City of Tigard

ADDENDUM #1

ENTRYWAY MONUMENTS PROJECT #CIP 2015-97024

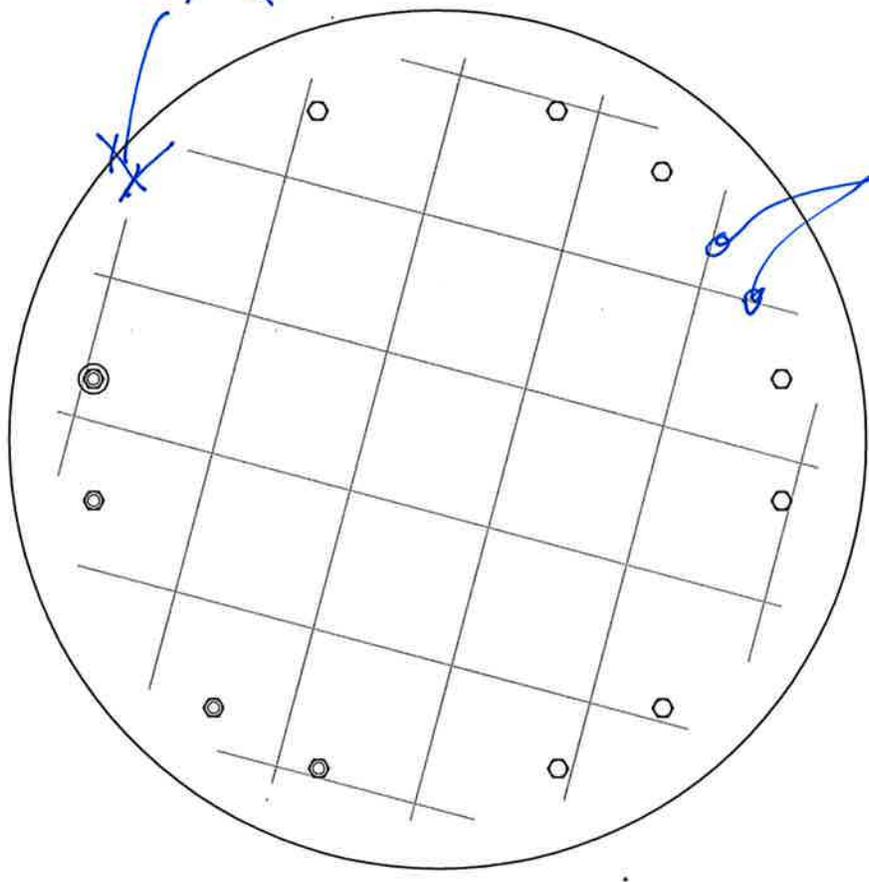
CLARIFYING INFORMATION TO DRAWINGS

Clarification on steel reinforcement for artwork footing.

3" CLEAR @ PERIMETER
3" @ TOP & BOTTOM

(6) #5"
@ 9" O.C.
PLACE
TO
AVOID
ANCHORS
